# Additional Items Related to SAE J1979

1. Differences between CCR1968.2(ISOR) and SAE J1979-2(DA)
  - Increment condition of mini-numerator and mini-denominator
  - NRCs(negative response code) allowed
2. Additional change
  - Related to CCM Readiness Bit not fixed to “completed”, additional changes needed.

Monitor Activity Ratio  
- Mini-Denominator

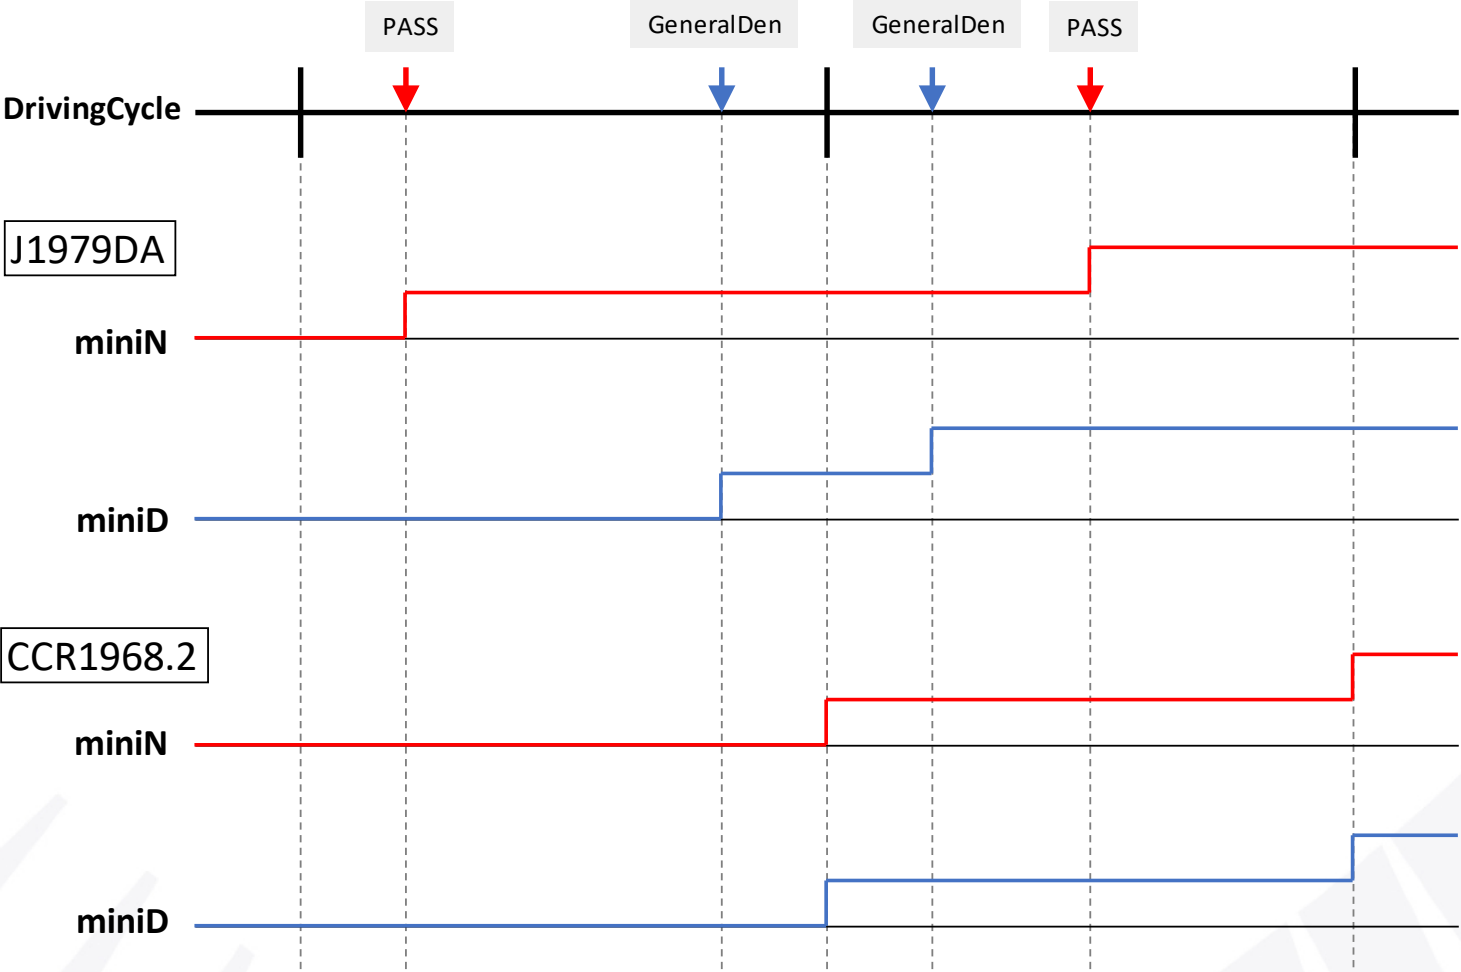
- Increment counter when the DEM receives a PASS report for the DTC
  - i.e. when DTC Status Bit 6 (*TestNotCompletedThisOperationCycle*) transitions from 1 to 0

mini-numerator:  
PASS reported by a monitor

Behavior

- Increment counter when the General Denominator increments

mini-denominator:  
when the general denominator increments
